RE: Change in Point of Diversion Water Right, File No 22383

DWR FIELD OFFICE APPLICATION FOR APPROVAL TO CHANGE THE PLACE OF USE AND/OR THE POINT OF DIVERSION

GMD3 Change Review

Change Application(s); PD
 File No(s). 22383; Earline Davis

Point of Diversion Change

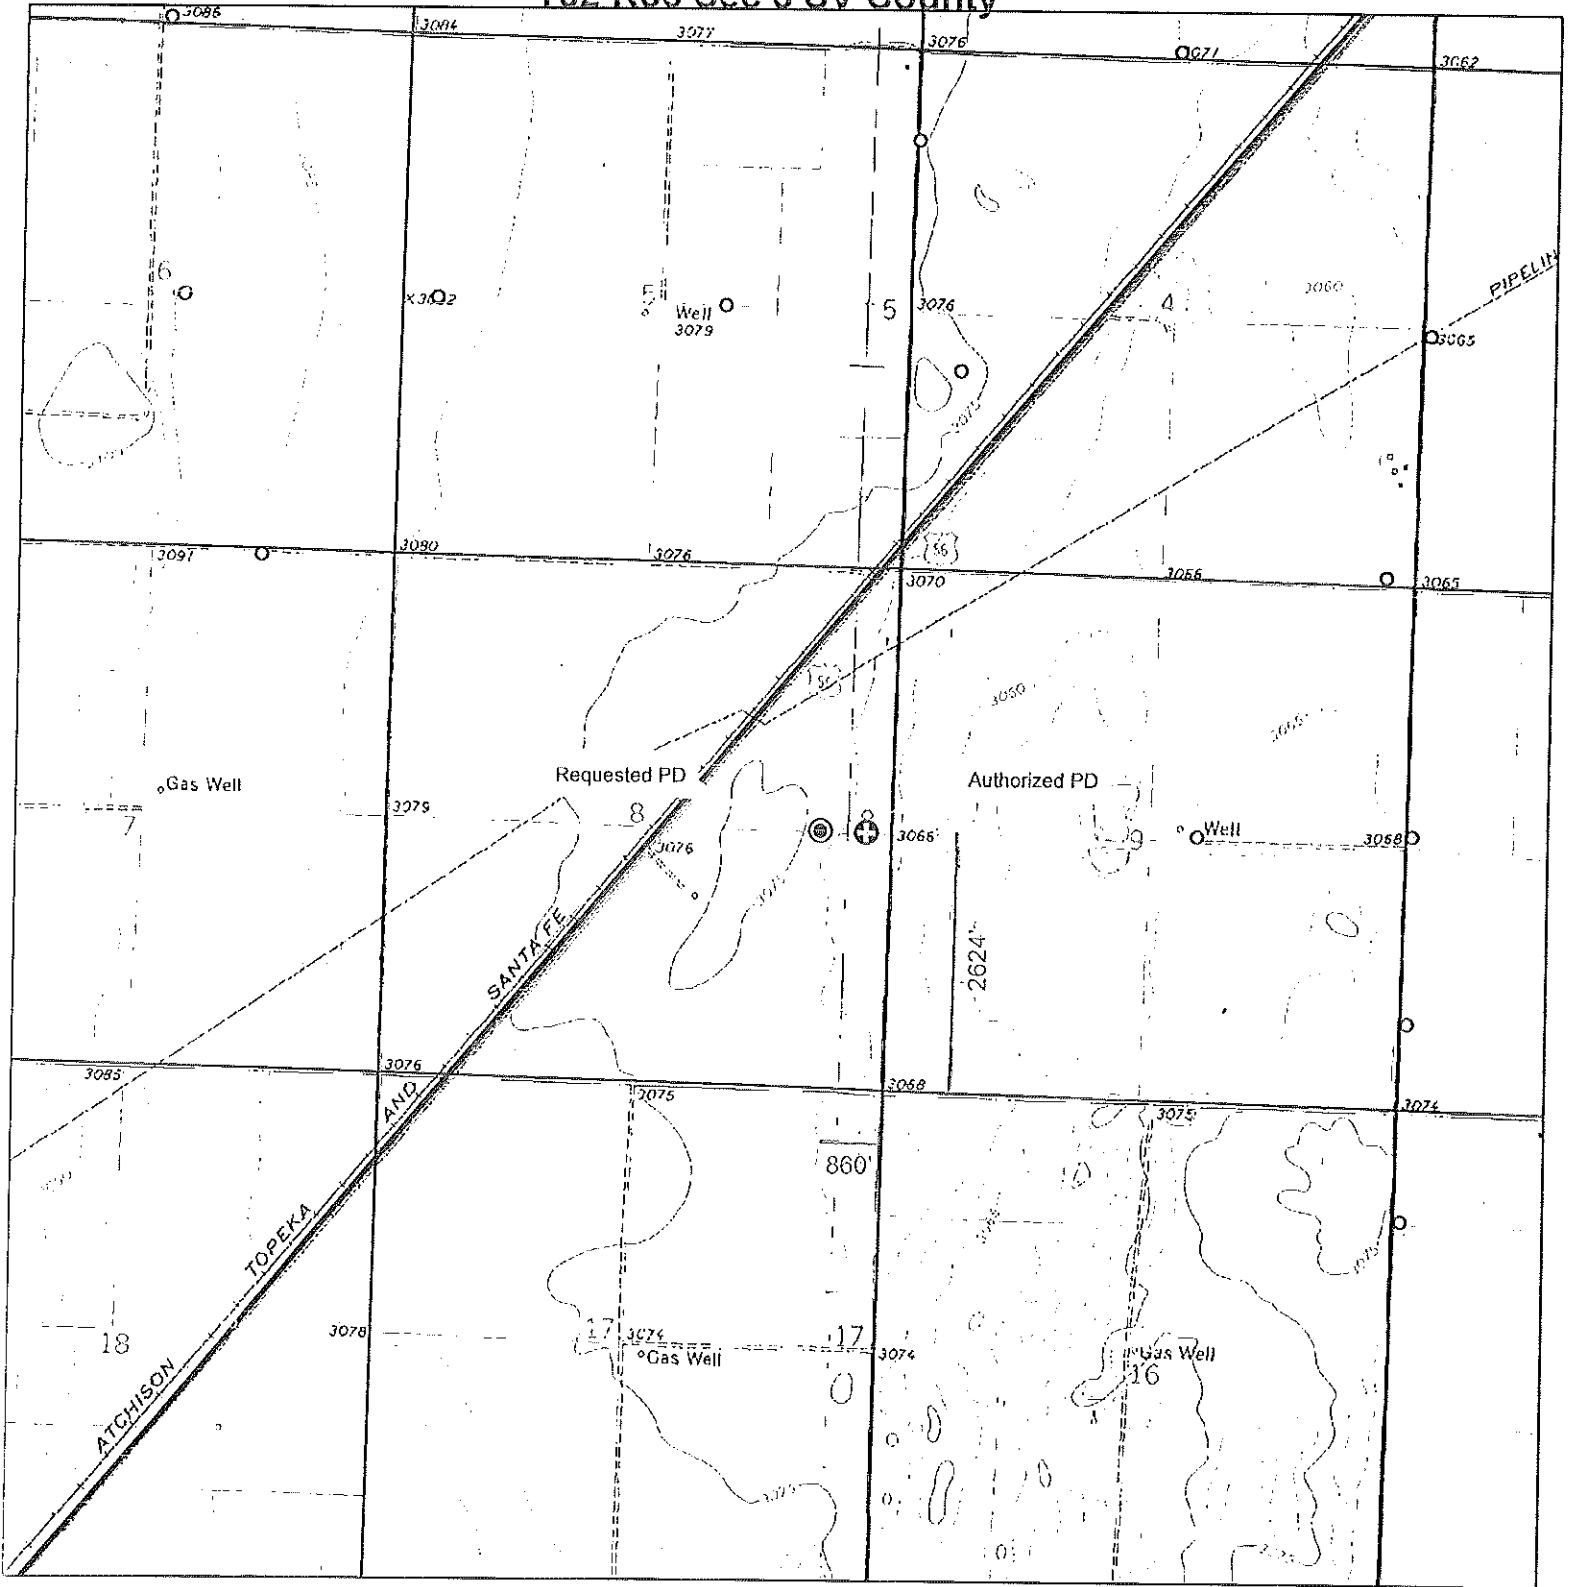
Earline Davis has applied to relocate the well authorized by the above water right number. There are no neighboring wells within ½ mile of the requested.

ft. North	ft. West	
Authorized PD	2600	310	Sect. 8-32-36
Proposed PD	2624	860	
Difference	-24 N	-550 W	
a2 + b2 = c2	576	302500	550.5234 foot move NW

We have completed a review of the application for the above referenced water right. The proposal is not in conflict with the Management Program of the Southwest Kansas Groundwater Management District No. 3 (GMD3). The proposed distance moved and spacing to neighboring wells is met in accordance with K.A.R. 5-23-3. It is therefore recommended that the application be approved at this time.
